Preservation Department – Item 1, LPC-22-08731

**6301 12th Avenue, aka 6301-6323 12th Avenue, 1202-1216 63rd
Street, and 1201-1215 64th Street – Angel Guardian Home –
Individual Landmark
Borough of Brooklyn**

LPC-22-08731: 6301 12th Avenue, Angel Guardian Home - Individual Landmark

PUBLIC MEETING SCOPE 09/20/2022

CHANGES:

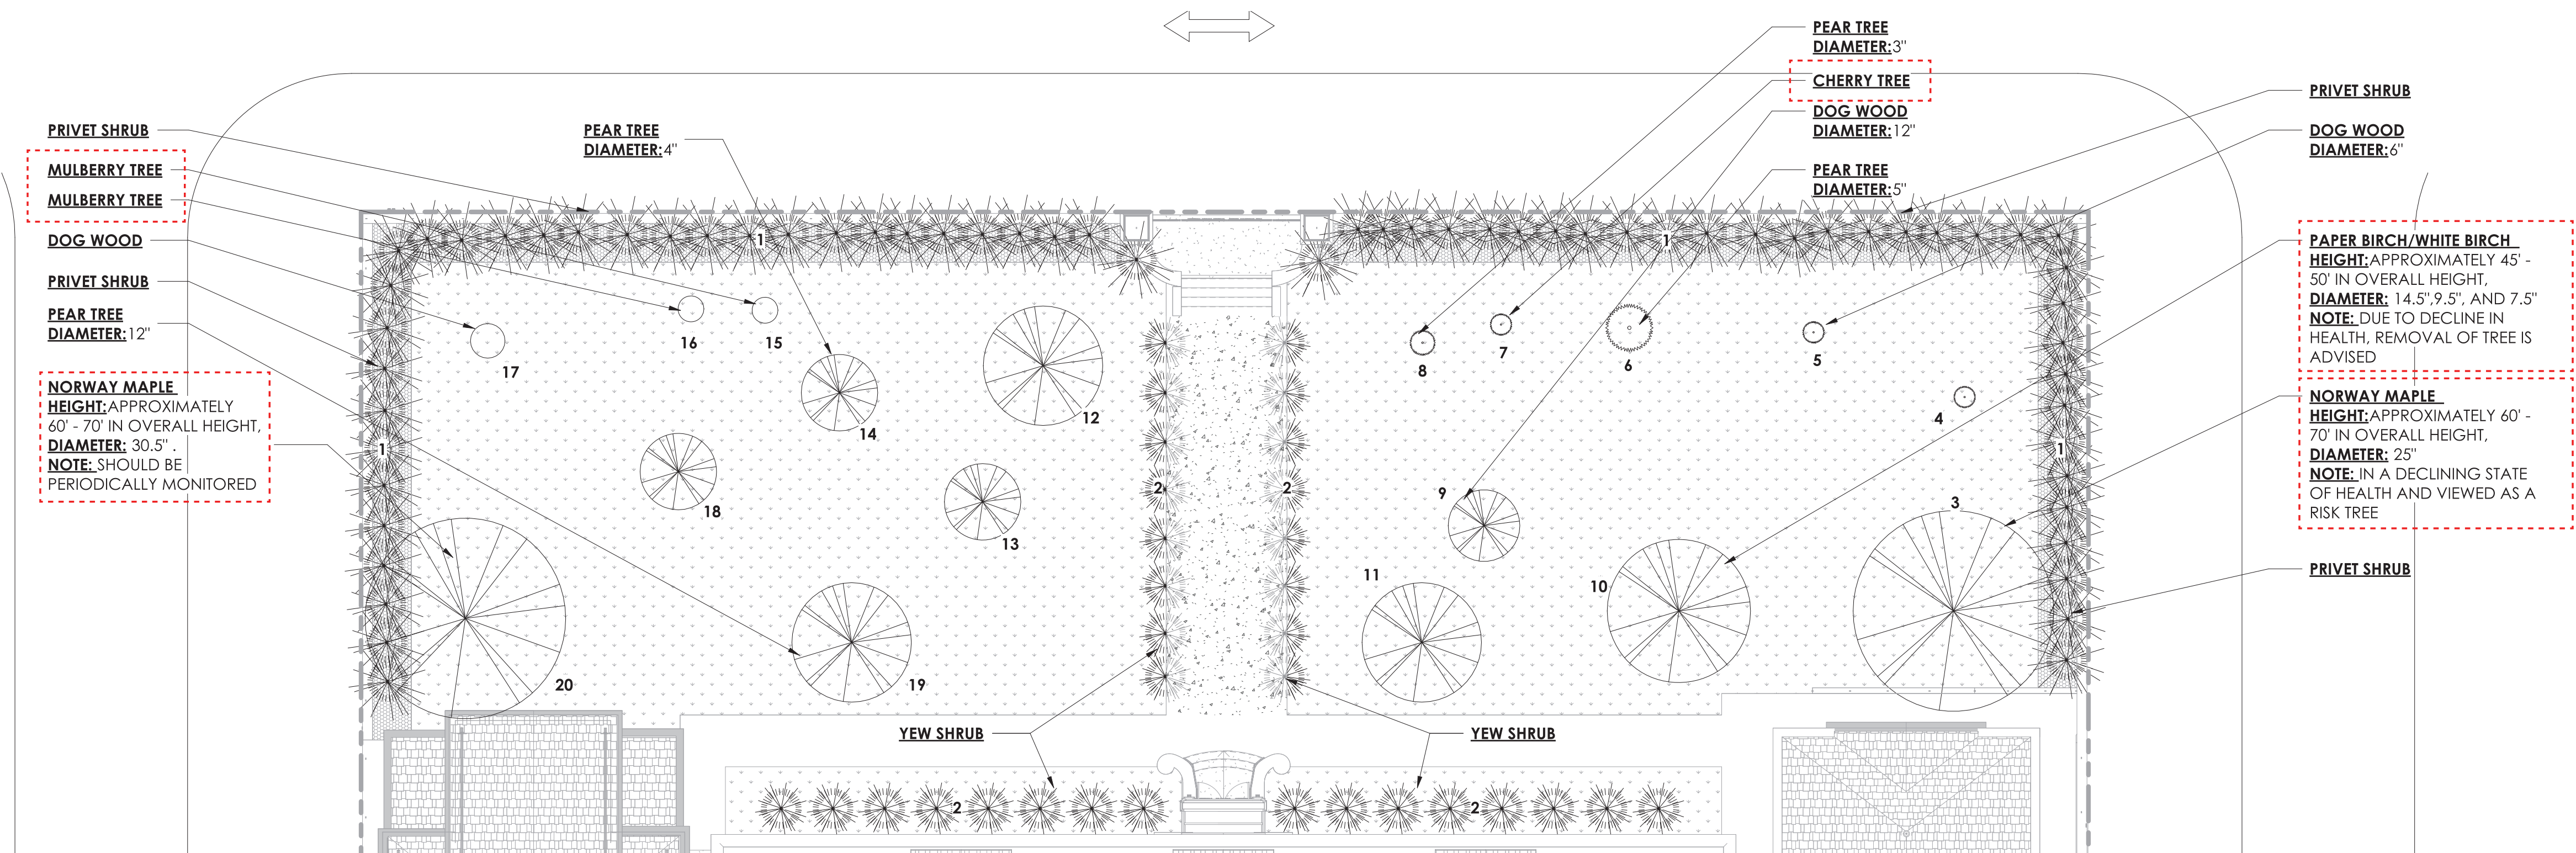
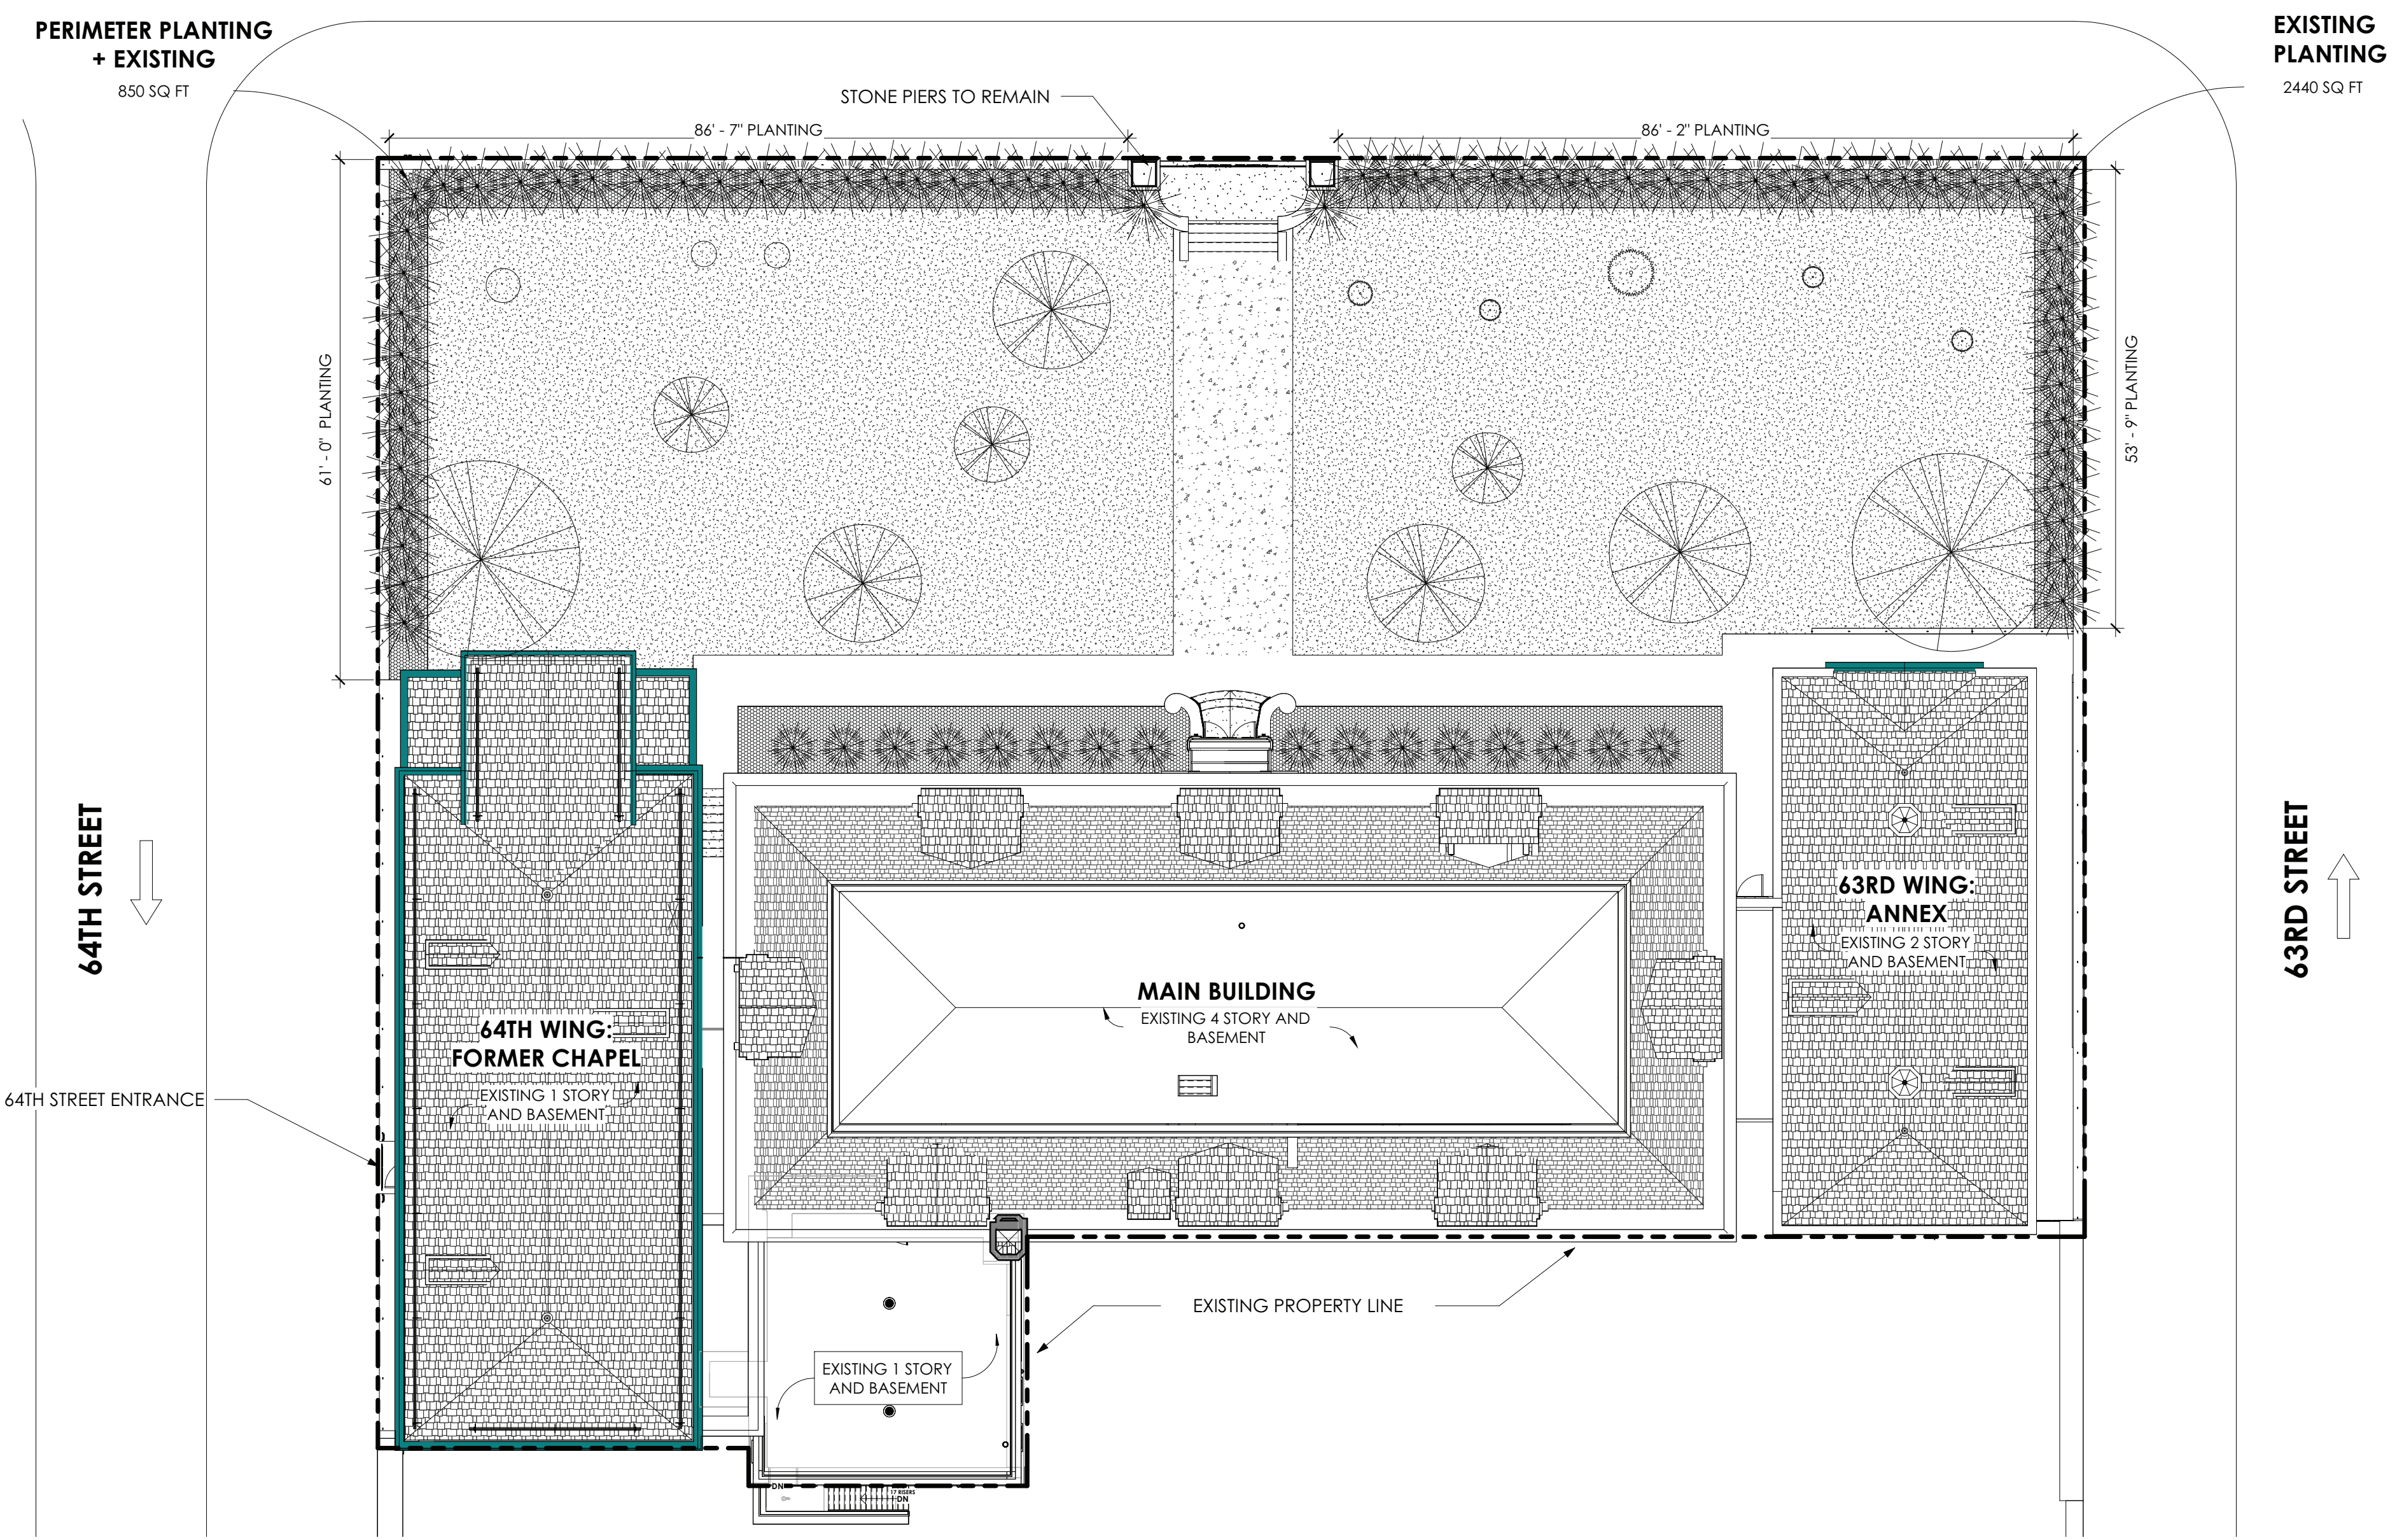
- PERIMETER PLANTING TO BE WIDENED AND MAINTAINED
- DEVELOPED PLAY AREAS AND DIVIDED UP THE POURED RUBBER PLAY SPACES
- PLACED GRASS BORDER THROUGHOUT THE PLAY SPACES
- REVISED LIGHT POLE PLACEMENT
- TREE IN FRONT OF 63RD ST WING TO BE REMOVED
- ADDITIONAL TREES TO REMAIN
